SERVICE BULLETIN

N° 139-726

ATA 31 – MODULAR AVIONIC UNIT (MAU) MARKING

VIEW B

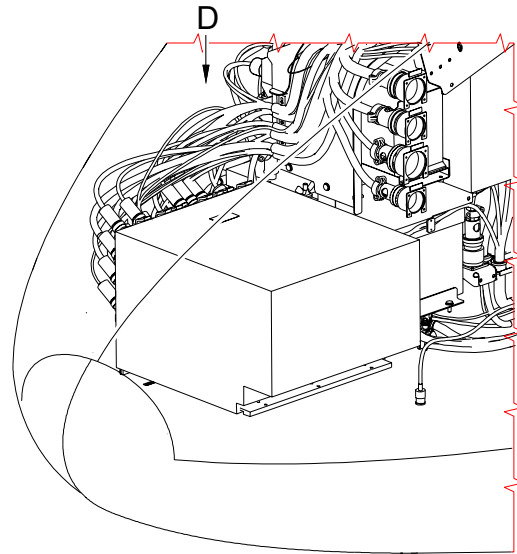
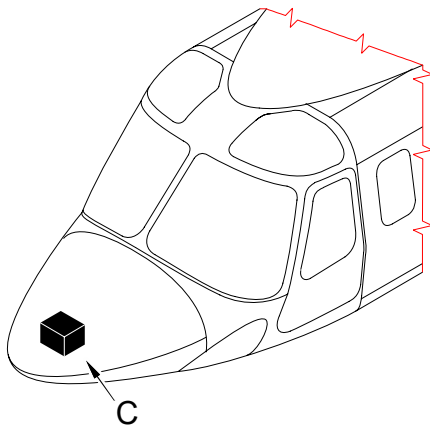
- 2.1.1 With reference to Figure 1 View B, mark the new P/N 3G4600A00137 and mark the S/N of the installed MAU followed by "/1" on the existing plate.

- 2.1.2 With reference to Figure 1 View B, remove the existing plate from the MAU cabinet.
- 2.1.3 With reference to Figure 1 View B, install the plate P/N A148A001B1 on the MAU cabinet.
- 2.1.4 With reference to Figure 1 View B, record the P/N 3G4600A00137 and the S/N of the installed MAU followed by "/1" on the new plate P/N A148A001B1.

REMOVE:
EXISTING PLATE
INSTALL:
A148A001B1 PLATE

REMARK THE S/N OF THE INSTALLED MAU
FOLLOWED BY "/1" ON THE PLATE

VIEW D

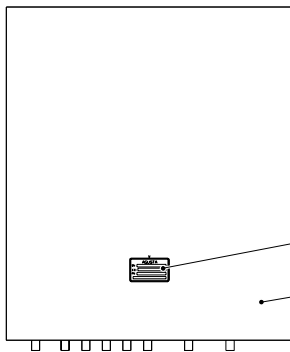
- 2.2.1 With reference to Figure 1 View D, mark the new P/N 3G4600A00235 and mark the S/N of the installed MAU followed by “/1” on the existing plate.

- 2.2.2 With reference to Figure 1 View D, remove the existing plate from the MAU cabinet.
 - 2.2.3 With reference to Figure 1 View D, install the plate P/N A148A001B1 on the MAU cabinet.
 - 2.2.4 With reference to Figure 1 View D, record the P/N 3G4600A00235 and the S/N of the installed MAU followed by “/1” on the new plate P/N A148A001B1.
3. In accordance with AMP DM 39-A-06-41-00-00A-010A-A re-install all external panels, internal panels and liners previously removed.
 4. Return the helicopter to flight configuration and record for compliance with this Service Bulletin on the helicopter logbook.
 5. Send the attached compliance form to the following mail box:

REMOVE:
EXISTING PLATE
INSTALL:
A148A001B1 PLATE

REMARK THE S/N OF THE INSTALLED MAU
FOLLOWED BY "/1" ON THE PLATE
